CIMARRON CORPORATION

**RE: Docket No. 70-925; License No. SNM-928
Response to NRC Comments on the Final Status Survey Report for Concrete
Rubble in Sub-Area "F"**

Staff Questions Regarding the FSSR for Concrete Rubble in Sub-Area "F" (April 16, 1998)

Figure 3-2. Horizontal dispersion coefficient as a function of downwind distance from the source.

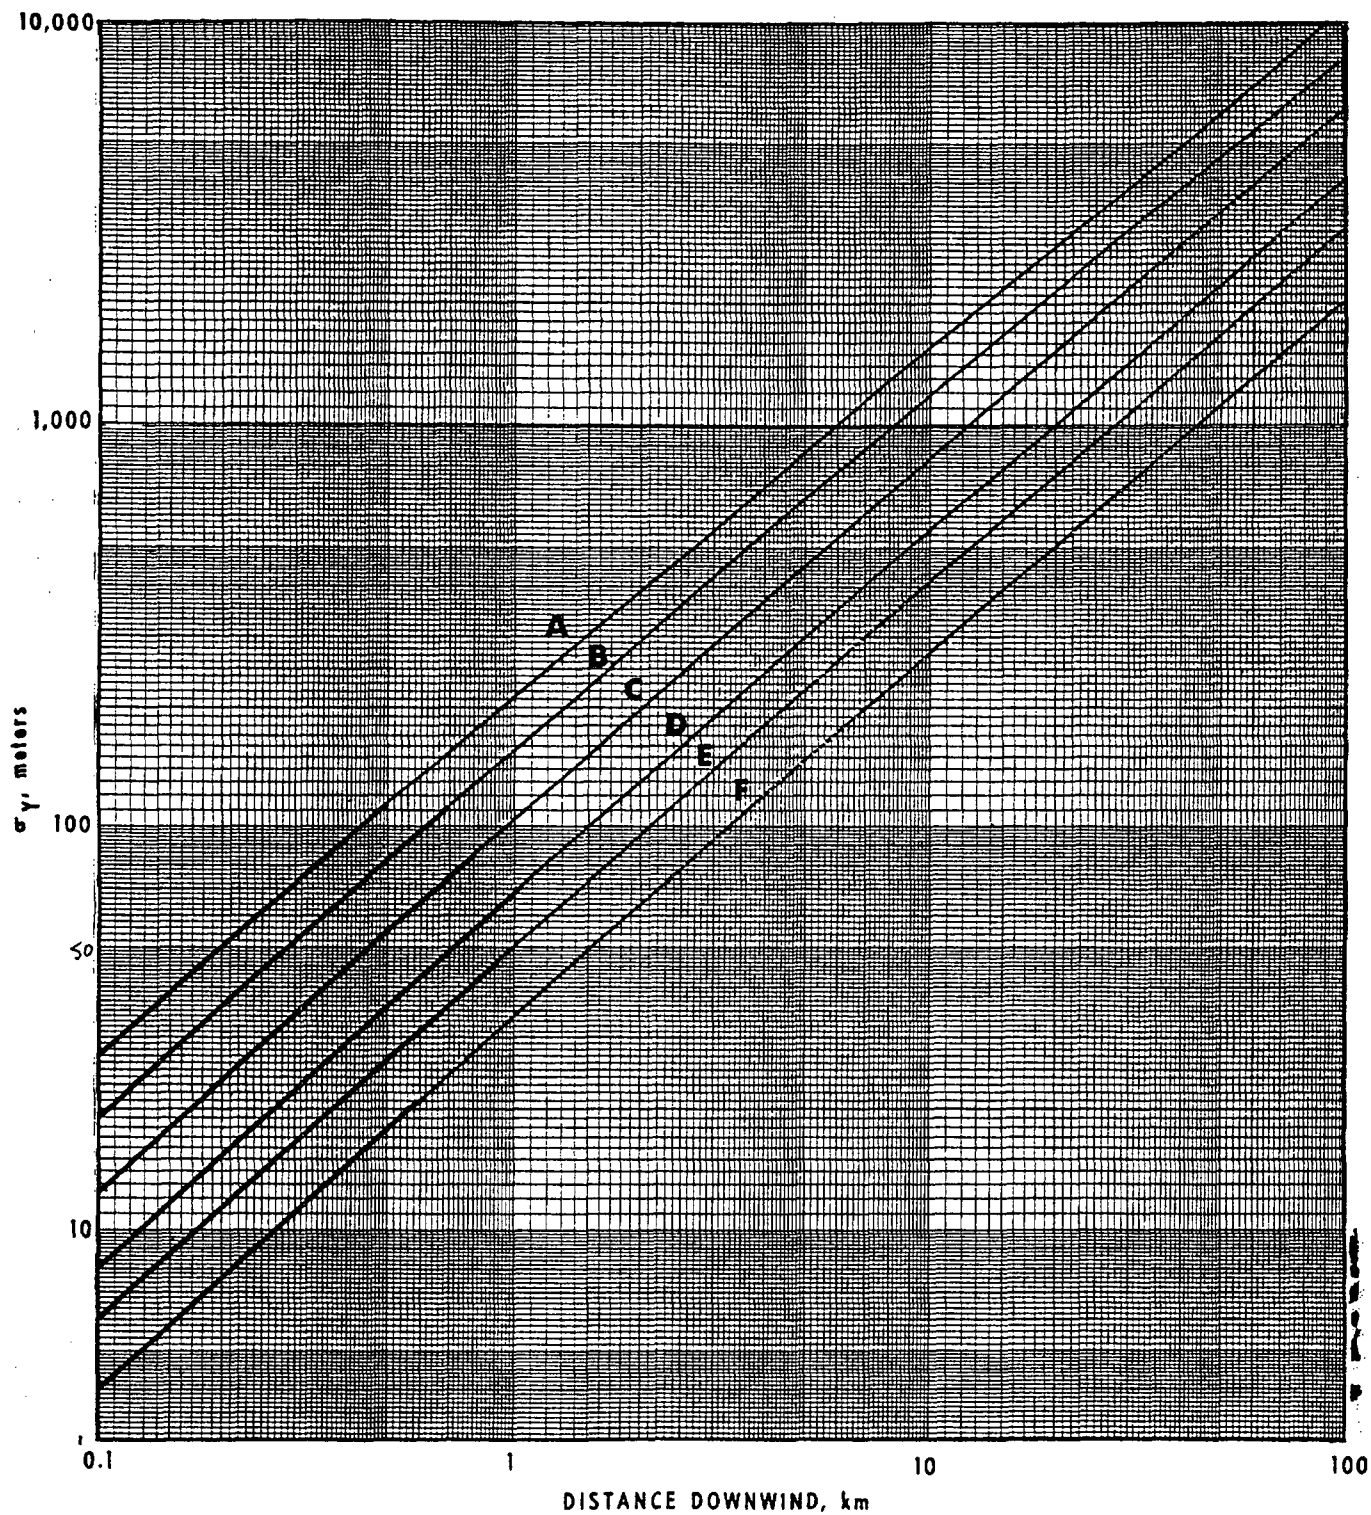
Please provide information and calculations to indicate the potential dose from inhalation of re-suspended materials from the concrete.

Sigma y and sigma z were picked from Figures 3-2 and 3-3 in Turner⁴ (Attachments 3 and 4), using Class D atmospheric stability curves.

$$\chi = 1.8 \text{ E-12 Ci/s} \div (2\pi)(6\text{m})(4.6\text{m})(5.6\text{m}) = 1.9 \text{ E-15 Ci/m}^3$$
